CCO SUBMITTAL

CCO No.: 42S1

Subject: Cable Tray Changes

CCO 42S1 Review Comments
By
Sandy Michelotti & Michael Travis
March 17, 2008

PIER W2 DETAILS NO.6

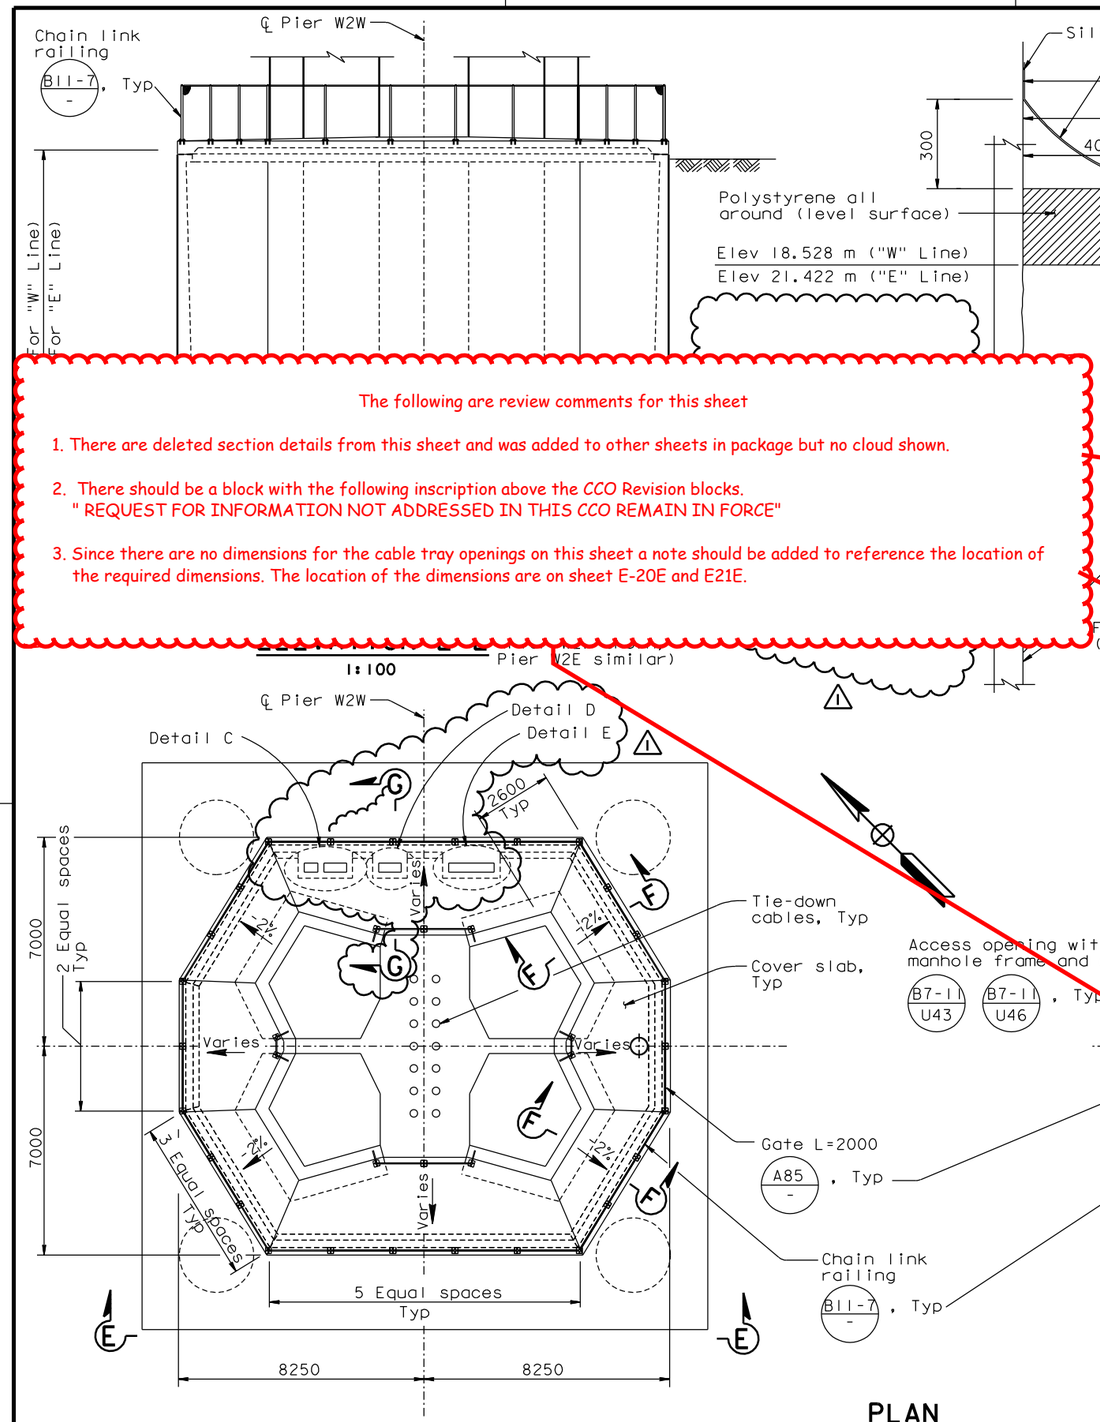
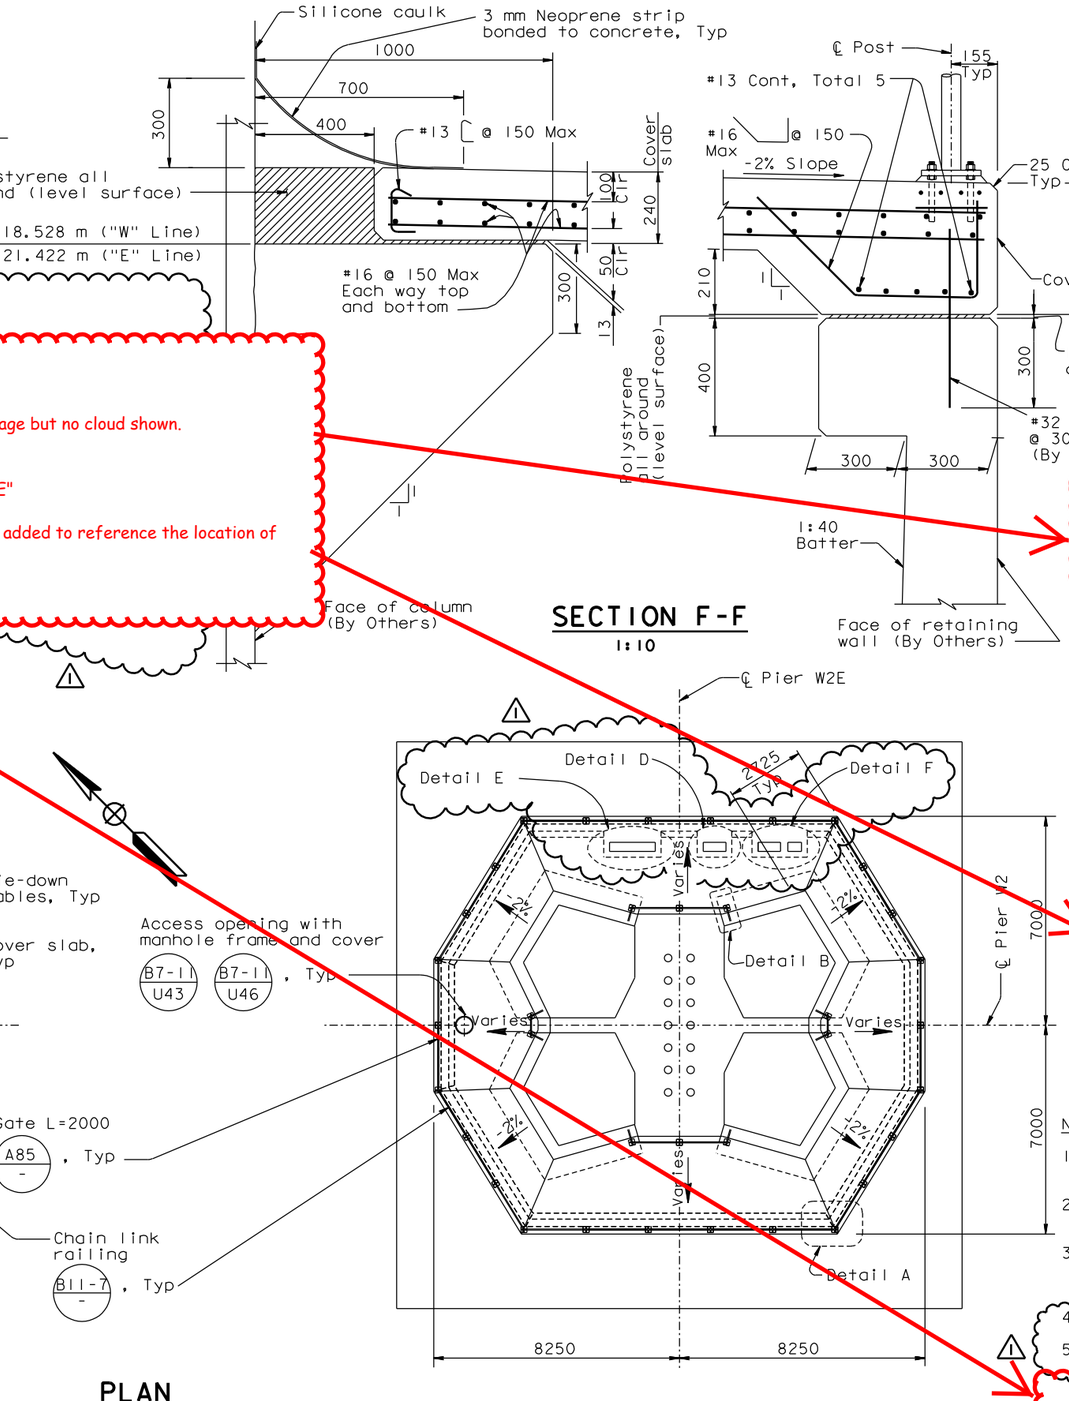
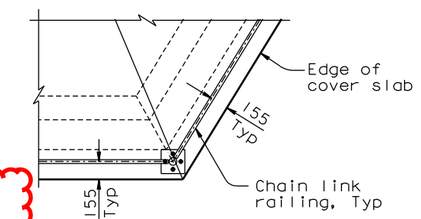
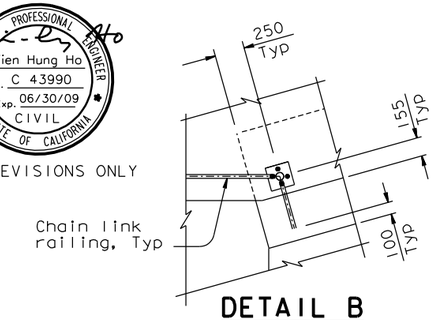
1. There are deleted section details from this sheet and was added to other sheets in package but no cloud shown.

2. There should be a block with the following inscription above the CCO Revision blocks.
" REQUEST FOR INFORMATION NOT ADDRESSED IN THIS CCO REMAIN IN FORCE"

3. Since there are no dimensions for the cable tray openings on this sheet a note should be added to reference the location of the required dimensions. The location of the dimensions are on sheet E-20E and E21E.

PIER W2 DETAILS NO. 6A

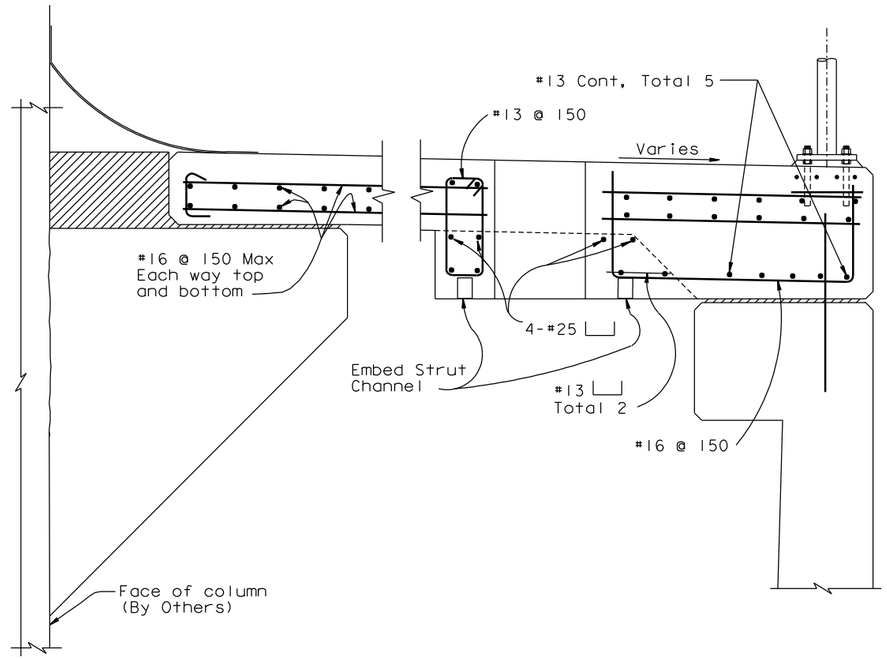
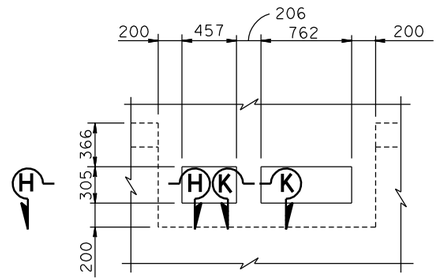
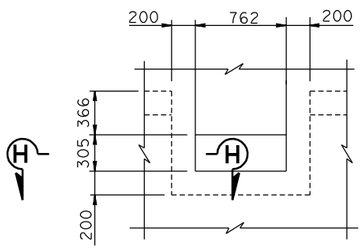
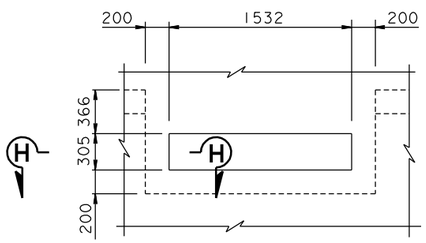
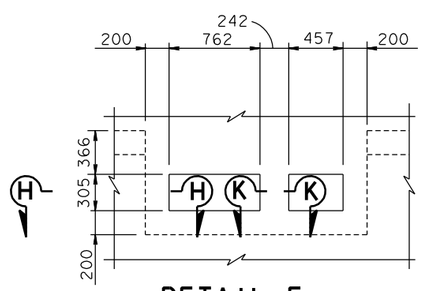
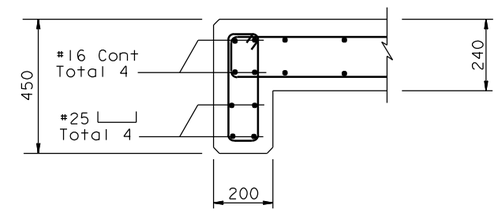
1. There should be a block with the following inscription above the CCO Revision blocks.
" REQUEST FOR INFORMATION NOT ADDRESSED IN THIS CCO REMAIN IN FORCE"

2. Since there are no dimensions for the cable tray openings on this sheet a note should be added to reference the location of the required dimensions. The location of the dimensions are on sheet E-20E and E21E.

LONGITUDINAL SHEAR PLATE ELEVATION (PP14 to PP15)

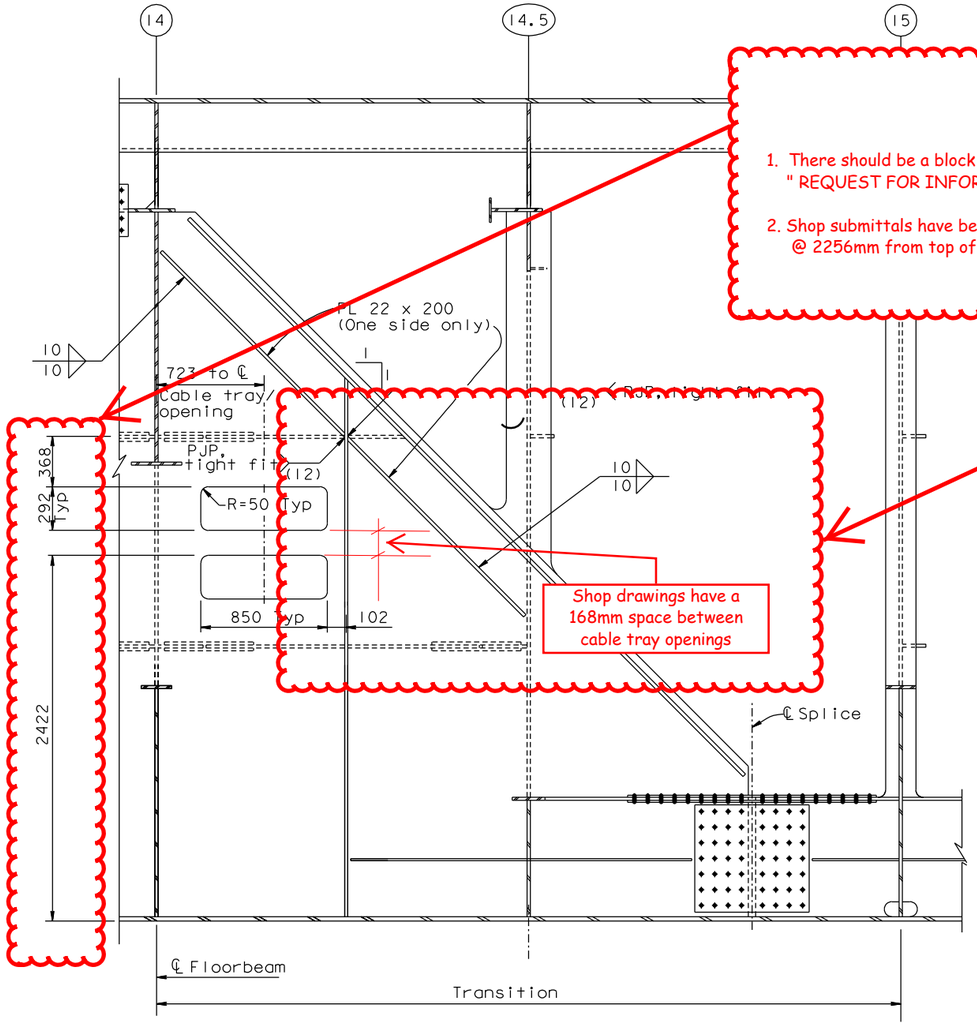
1. There should be a block with the following inscription above the CCO Revision blocks.
   " REQUEST FOR INFORMATION NOT ADDRESSED IN THIS CCO REMAIN IN FORCE"

2. Shop submittals have been approved with openings with a 168 mm space between openings and the bottom opening @ 2256mm from top of bottom plate. The dimensions on this sheet need to be reviewed and verified.

FLOORBEAM AT EAST TRANSITION NO.2

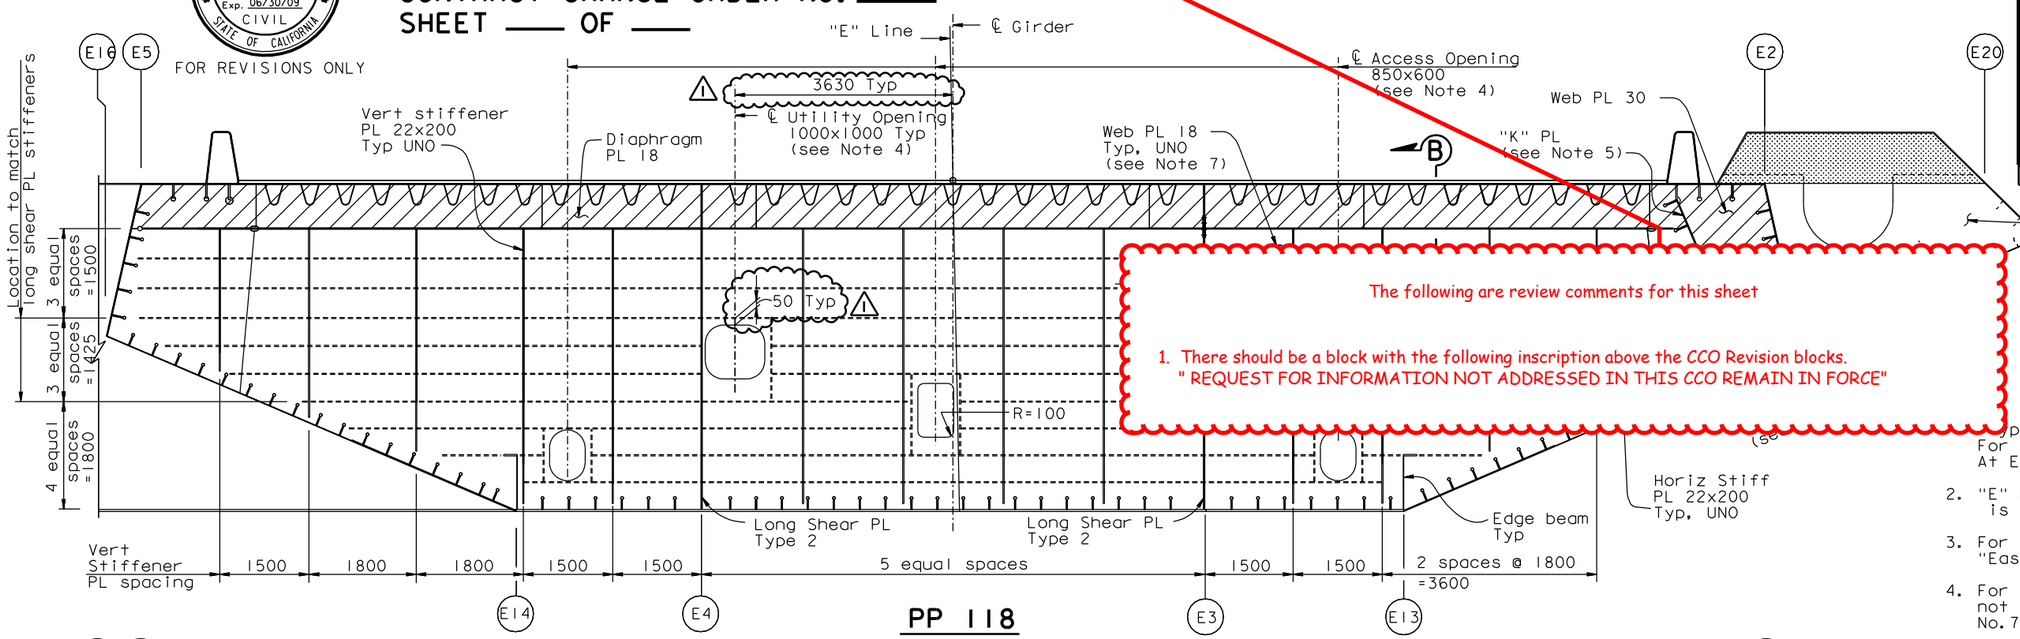
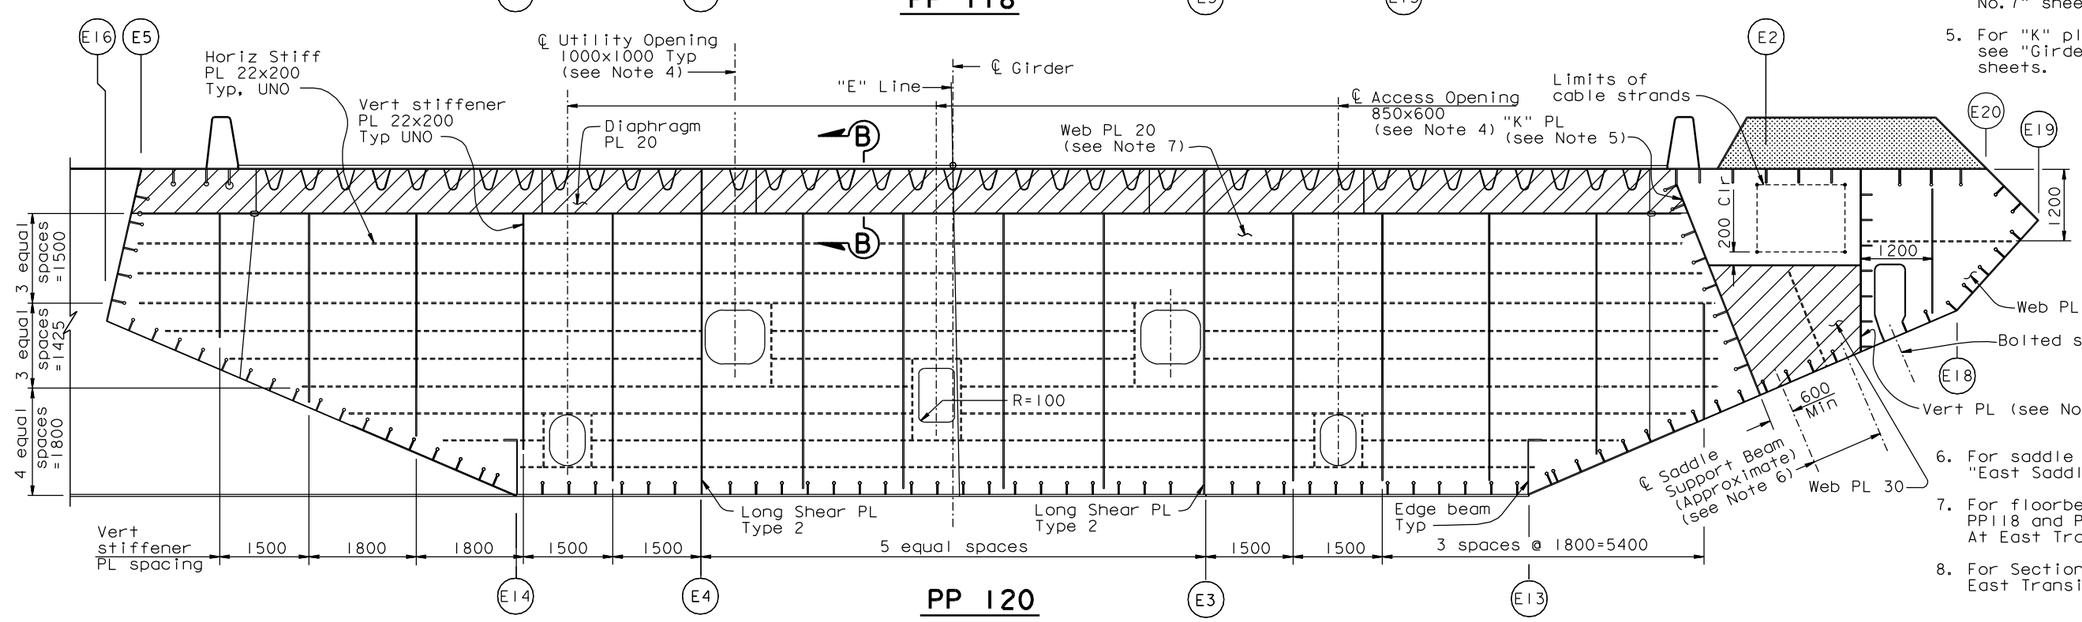
1. There should be a block with the following inscription above the CCO Revision blocks.
" REQUEST FOR INFORMATION NOT ADDRESSED IN THIS CCO REMAIN IN FORCE"

UTILITY LAYOUT

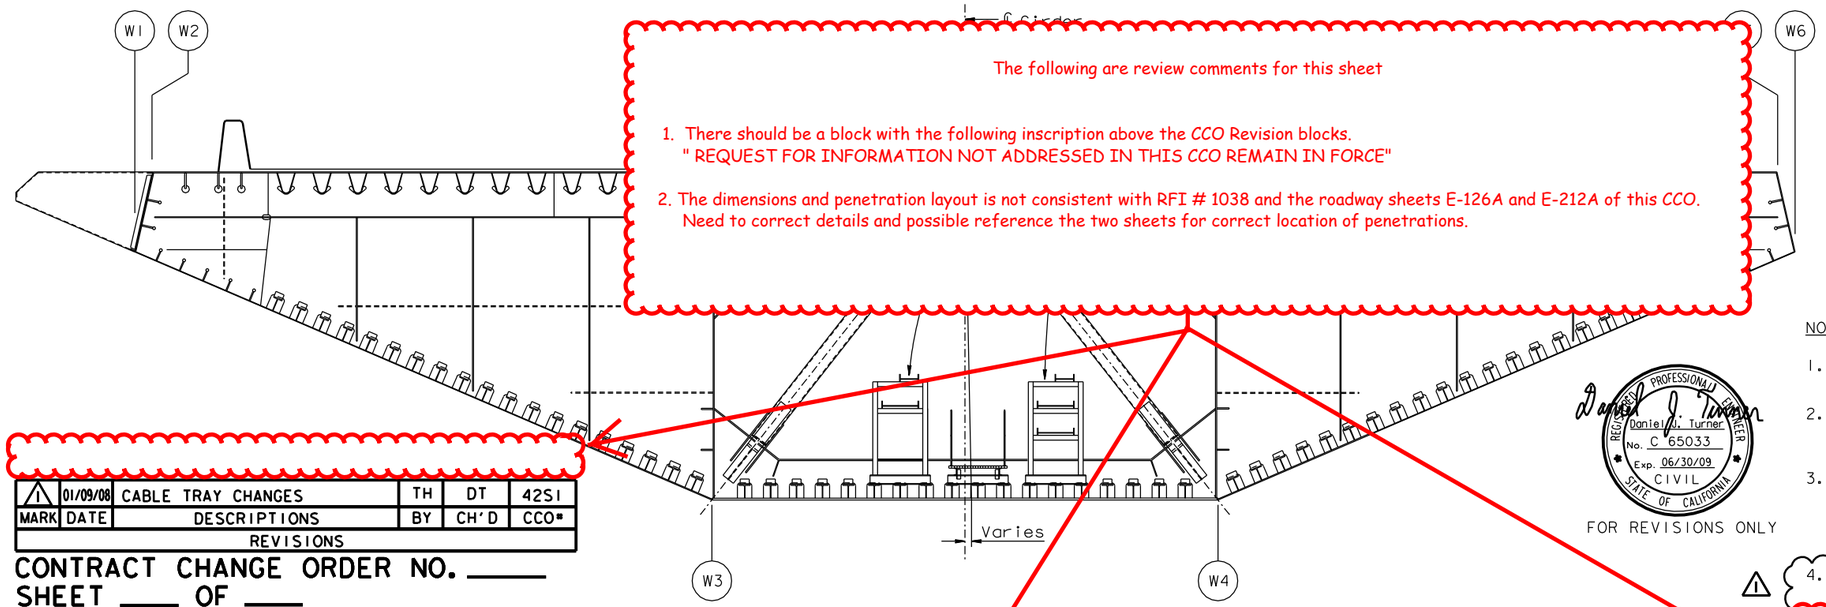
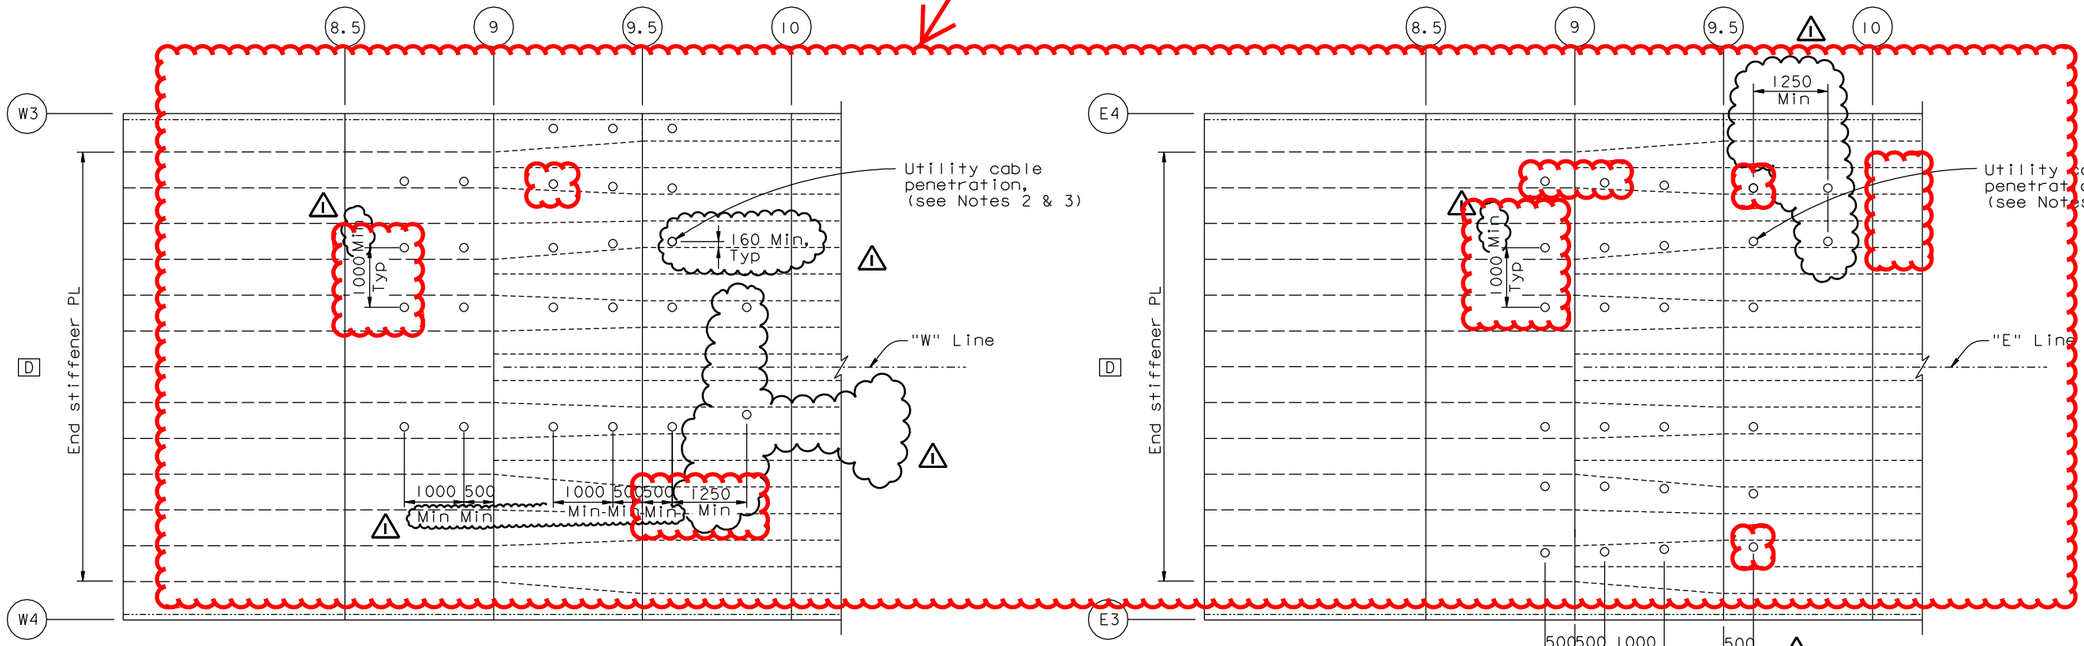
1. There should be a block with the following inscription above the CCO Revision blocks.
   " REQUEST FOR INFORMATION NOT ADDRESSED IN THIS CCO REMAIN IN FORCE"
2. The dimensions and penetration layout is not consistent with RFI # 1038 and the roadway sheets E-126A and E-212A of this CCO. Need to correct details and possible reference the two sheets for correct location of penetrations.
